# REGIONAL REVIEW NOTIFICATION

**ARC REVIEW CODE:** R2011231

**Name of Proposal:** Circle 75 (DRI #3169)

**CIRCLE 75 PARKWAY DRI**  
**Cobb County**  
**Natural Resources Group Review Comments**  
**November 23, 2020**

TITLE  
DRI SITE PLAN (EAST)

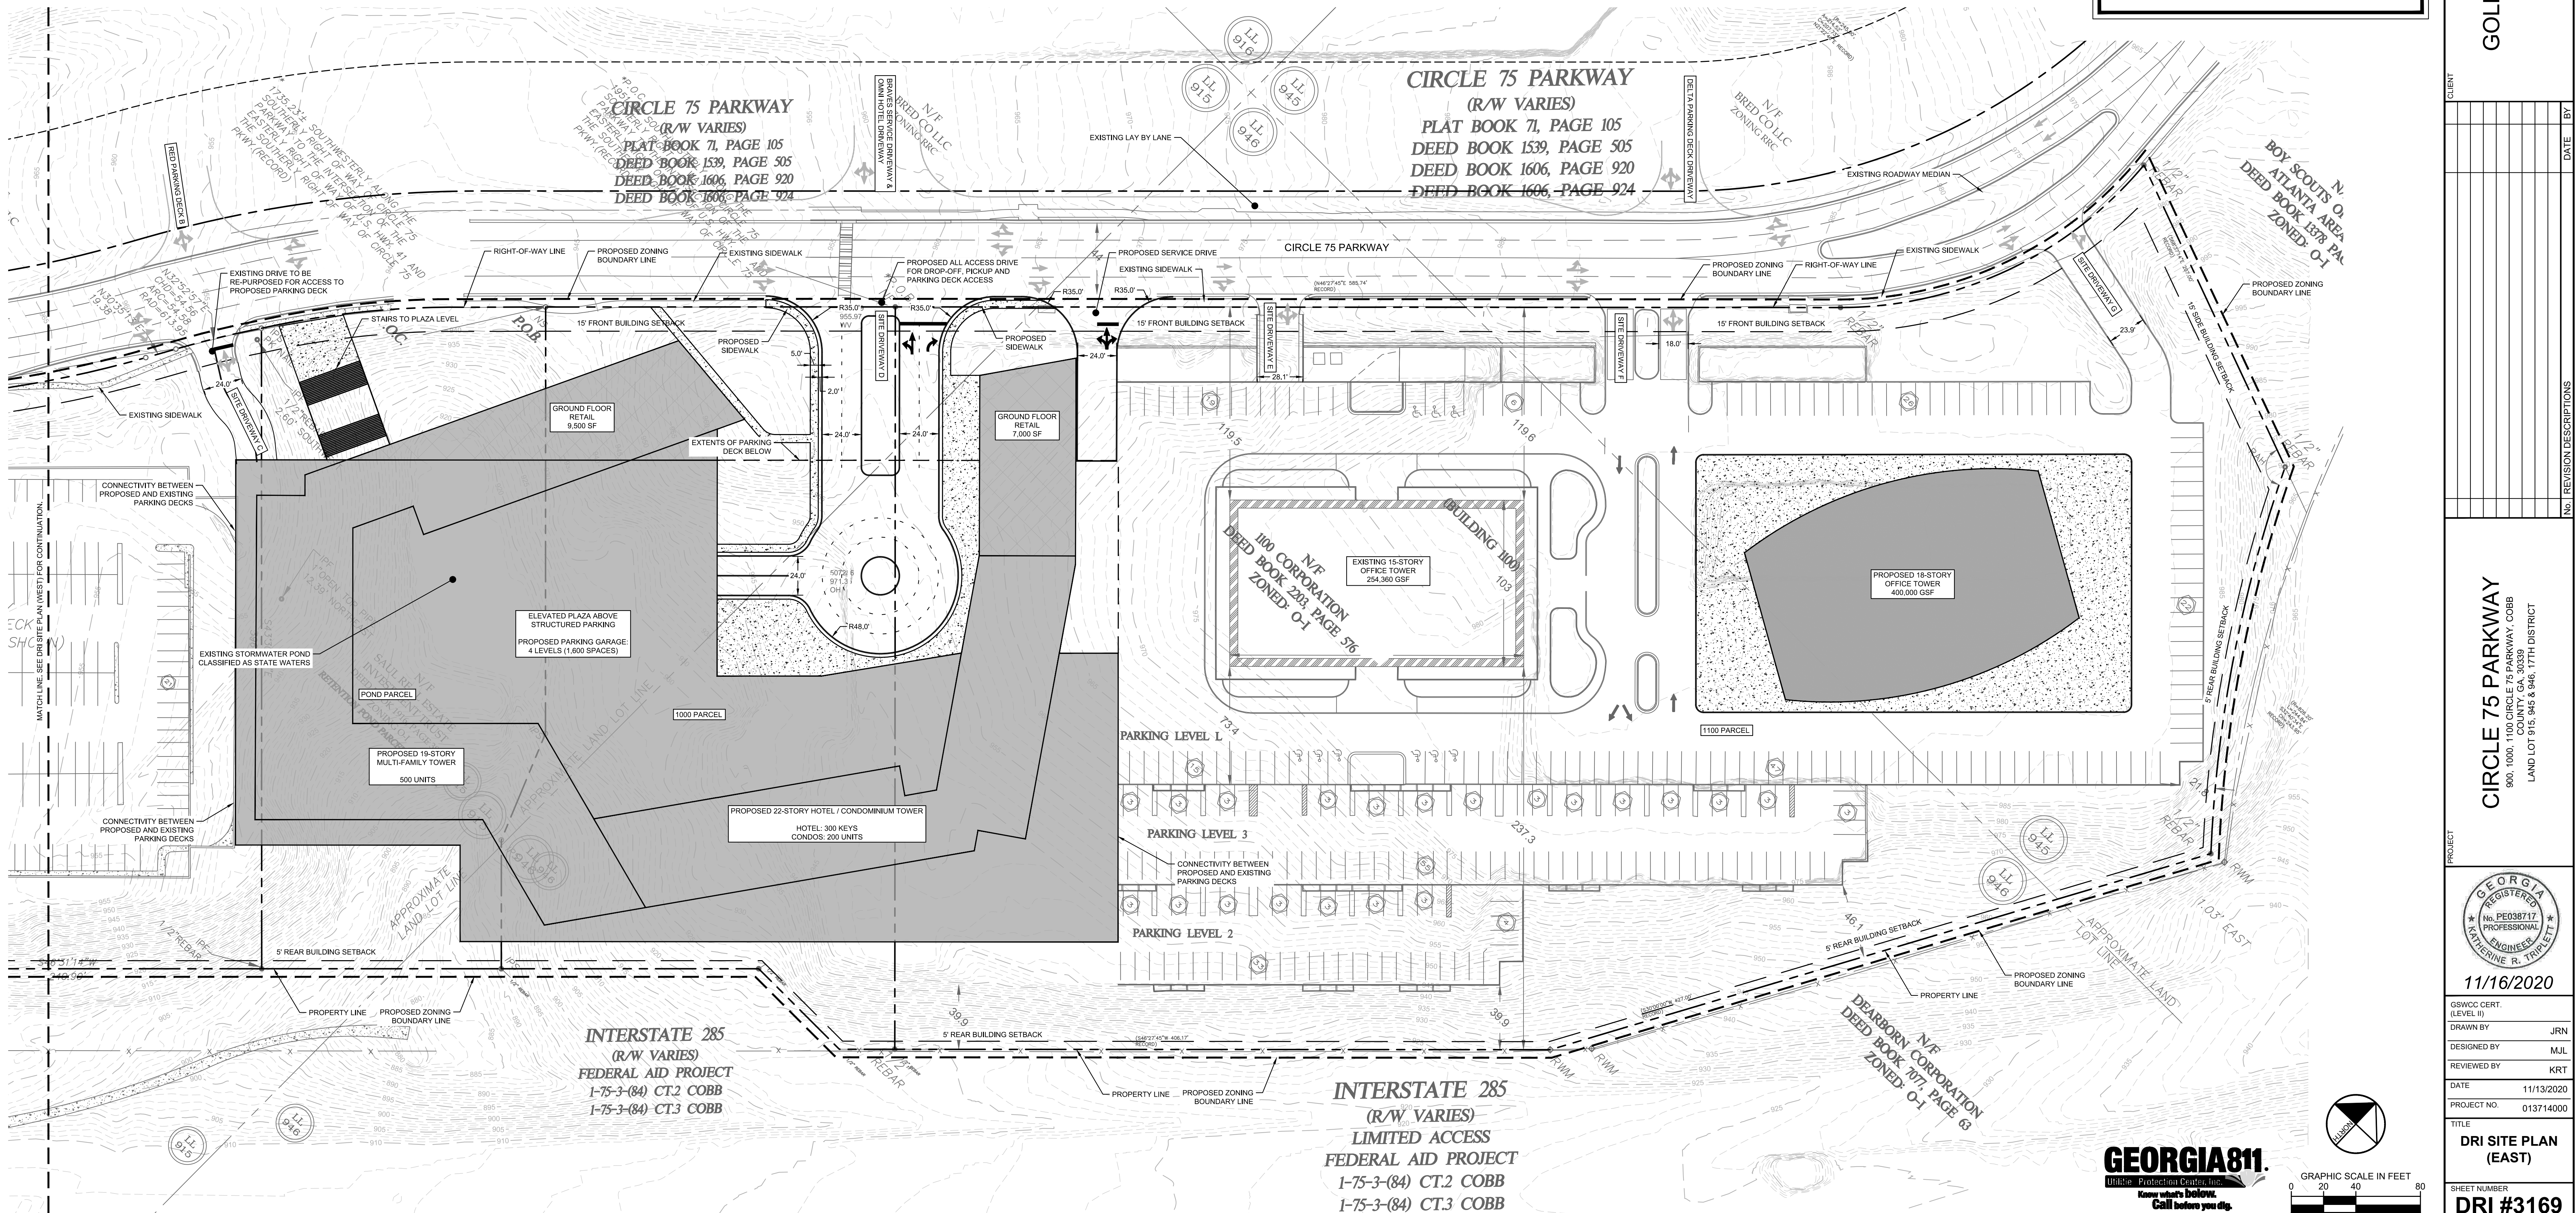
For example, the site plan currently shows existing sidewalks (approximately 4 feet wide, the bare minimum for ADA) and long curb radii (35 feet) that allow turning vehicles to carry high speeds into pedestrian zones and lengthen crossing distances. There is currently no legal or safe option for pedestrians to cross Circle 75 Parkway shown on the site plan, other than by accessing the existing pedestrian bridge located at the southwestern end of the site. The estimated walking distance for an office worker or event attendee who parks at the proposed new office tower at the northeastern end of the DRI site is 0.4 miles to the pedestrian bridge, then a similar distance back up to the nearest admission gate for the stadium. If the DRI is intended to serve the stadium development and vice versa, then additional pedestrian crossings must be provided.

The intersection at Site Driveway D and the Braves service driveway doesn't currently show a signalized intersection or pedestrian crosswalk. This is the most logical location for a new crossing, but it will depend on ongoing discussions with Cobb Department of Transportation, Georgia Department of Transportation, and Georgia Regional Transportation Authority to determine future improvements to Circle 75 Parkway that incorporate a safe crosswalk, preferably with a sheltered median. Another factor to consider for pedestrians and cyclists is the multi-use trail on the other side of Circle 75, which is a part of the Cumberland area's trail network and provides access to the Bob Callan Trail, Rottenwood Creek Trail, and the Chattahoochee River National Recreation Area beyond. The site is currently served by CobbLinc route #15, with two stops on either side. Future streetscape design should seek input from CobbLinc staff to locate these stops in the appropriate location for safe pedestrian crossings and provide shelters and other amenities.
